## 10.2 Turbine Generator

The information in this section of the reference ABWR DCD, including all subsections, tables and figures, is incorporated by reference with the following departures and supplements.

Figure 10.2-1 Turbine Stop Valve Closure Characteristic

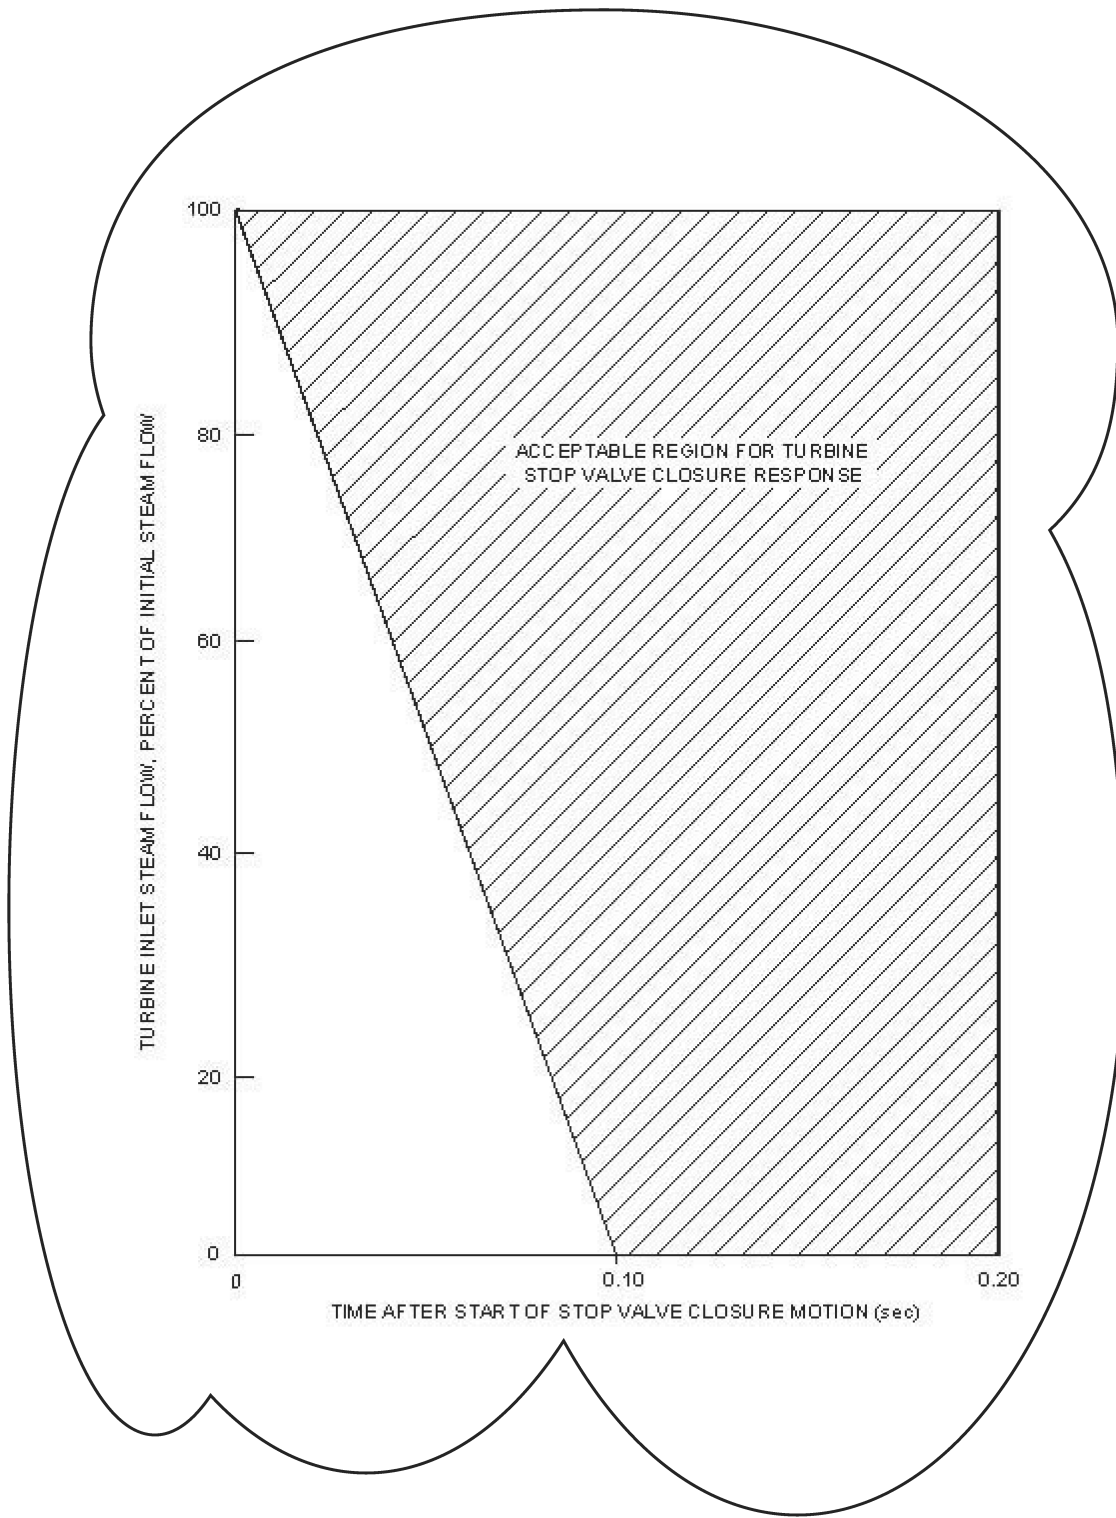
STD DEP Admin (Figure 10.2-1)

**Figure 10.2-4 Generator Hydrogen and CO<sub>2</sub> System**

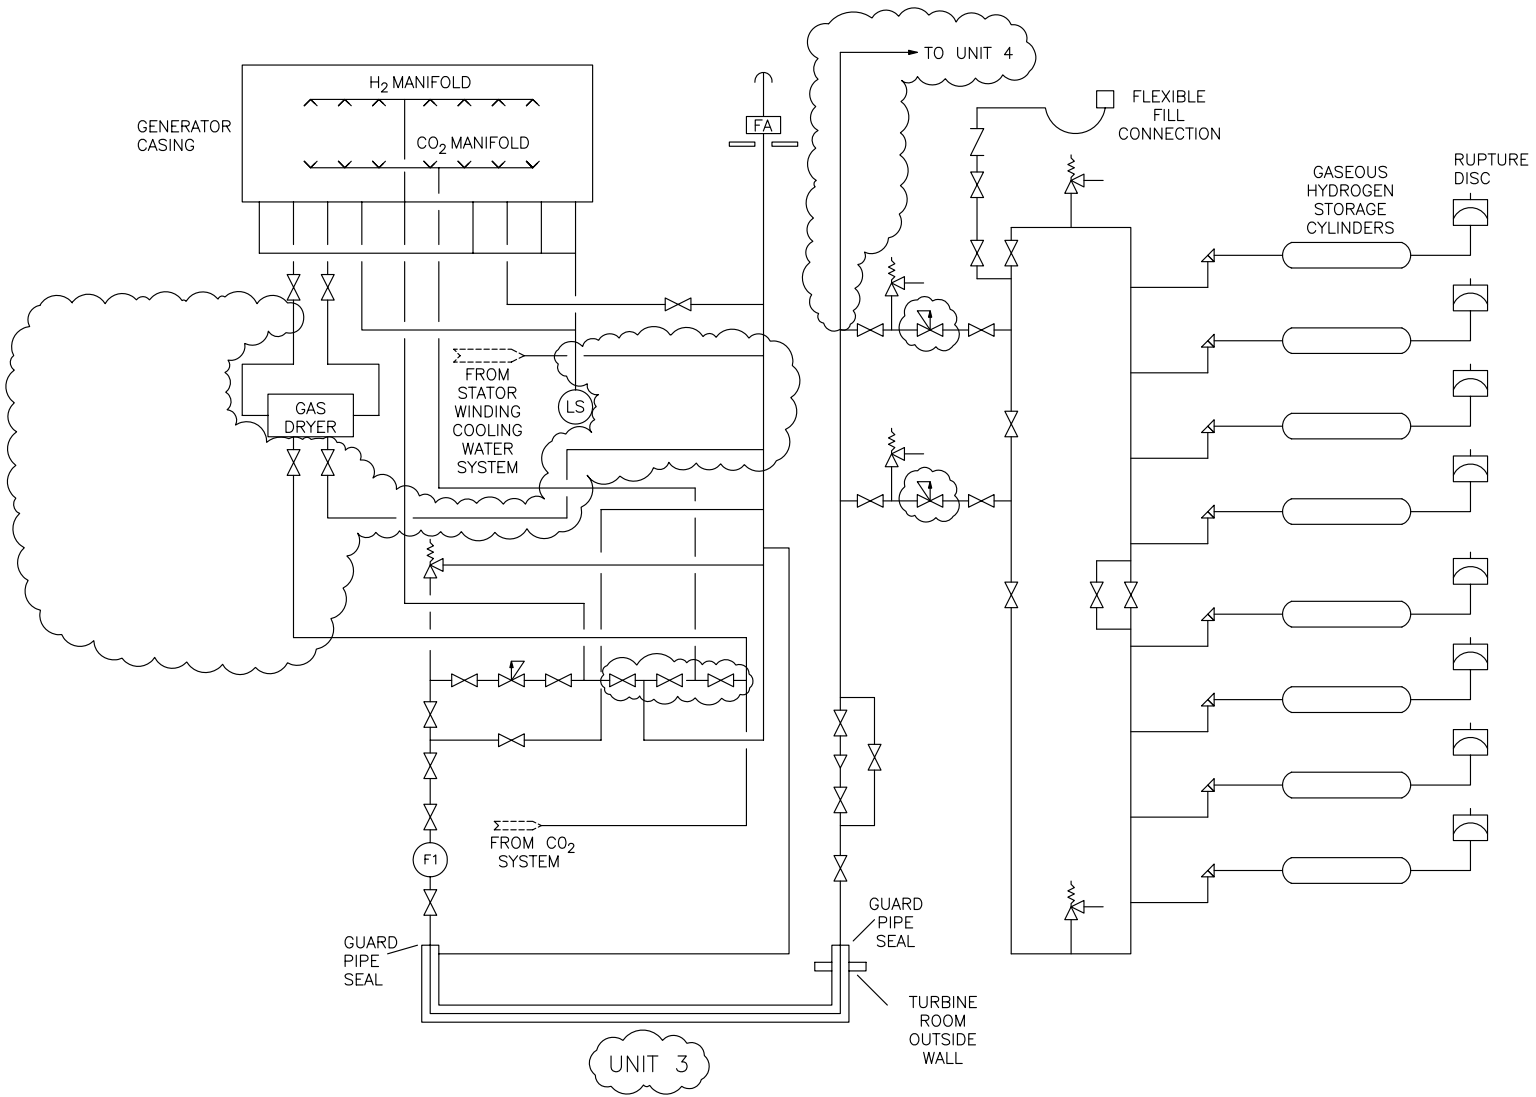
[STP DEP 1.1-2 \(Figure 10.2-4\)](#)

STP DEP 10.2-1 [\(Figure 10.2-4\)](#)

**Bulk Hydrogen System**—The bulk hydrogen and CO<sub>2</sub> system is illustrated on Figure 10.2-4. The hydrogen system is designed to provide the necessary flow and pressure at the main generator for purging carbon dioxide during startup and supply makeup hydrogen for generator leakage during normal operation.
